**Development of a Programmatic Agreement for the
Ross In-Situ Uranium Recovery Project
Crook County, Wyoming**

PROGRAMMATIC AGREEMENT
AMONG
THE U.S. NUCLEAR REGULATORY COMMISSION,
THE ADVISORY COUNCIL ON HISTORIC PRESERVATION,
THE WYOMING STATE HISTORIC PRESERVATION OFFICE,
AND
[THE U.S. BUREAU OF LAND MANAGEMENT,
STRATA ENERGY, INC., CONSULTING TRIBES, CROOK COUNTY MUSEUM
DISTRICT, ALLIANCE FOR HISTORIC WYOMING]
REGARDING
THE ROSS IN-SITU URANIUM RECOVERY PROJECT
IN CROOK COUNTY, WYOMING

DRAFT Appendix A – Undertaking and Area of Potential Effects

Ross Project Area of Potential Effects

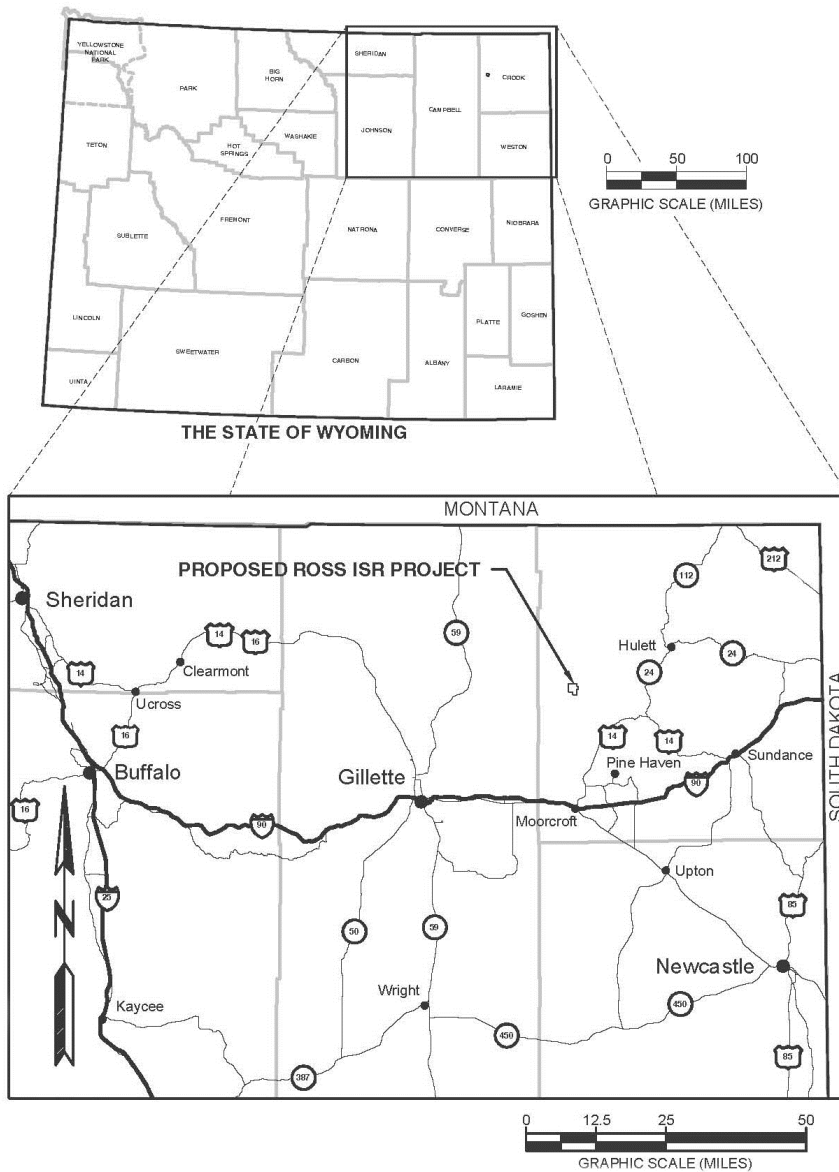
Comment [A3]: Suggest area inside license boundary only for direct impacts and support with ER Figs 1.2-6 and/or 1.2-7.

Comment [A4]: This seems misplaced here, at least as written. Is the point that if there are no visual effects outside of the property boundary, the APE has appropriately been defined as the project boundary? What about noise and vibration? Any other indirect effects from the project that could potentially affect historic properties?

Table 3. Summary of Ross Project Traditional Cultural Properties

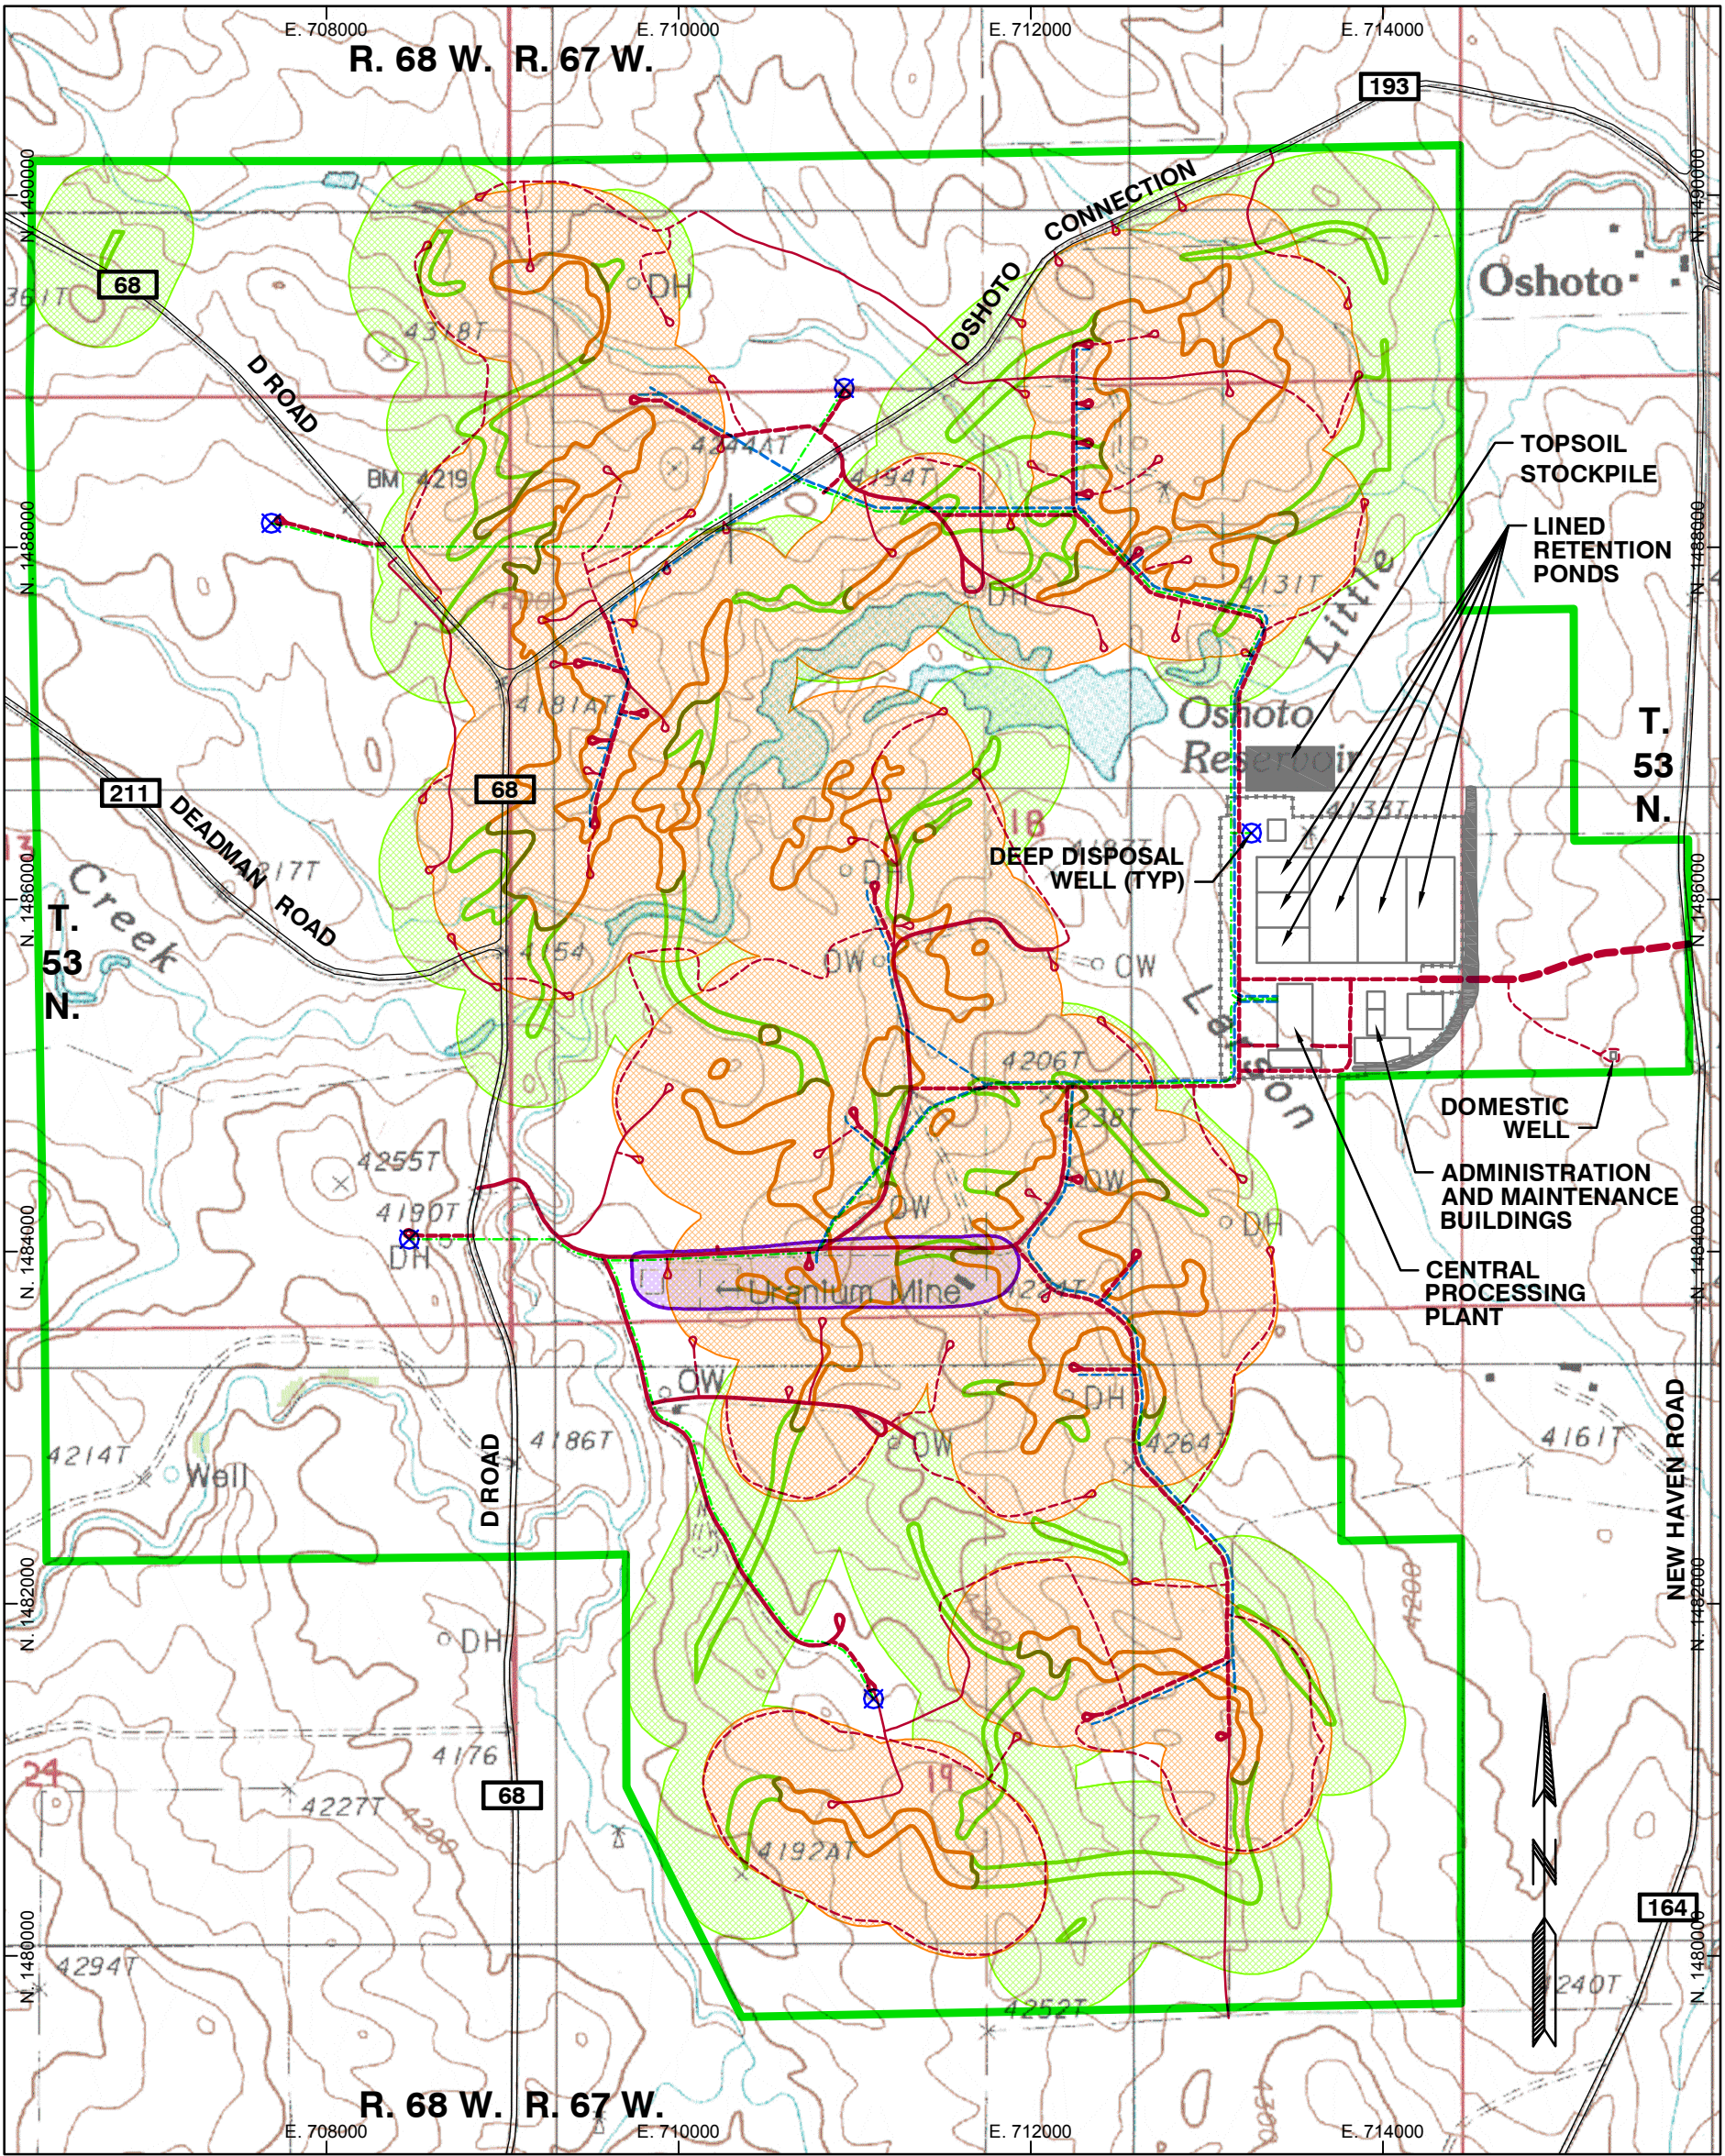
Comment [A5]: Need reference for Table 3.

Comment [A6]: Inconsistent with structure of proposed stipulation re: additional plan required of Strata? And Strata's recommendation re: eligibility?
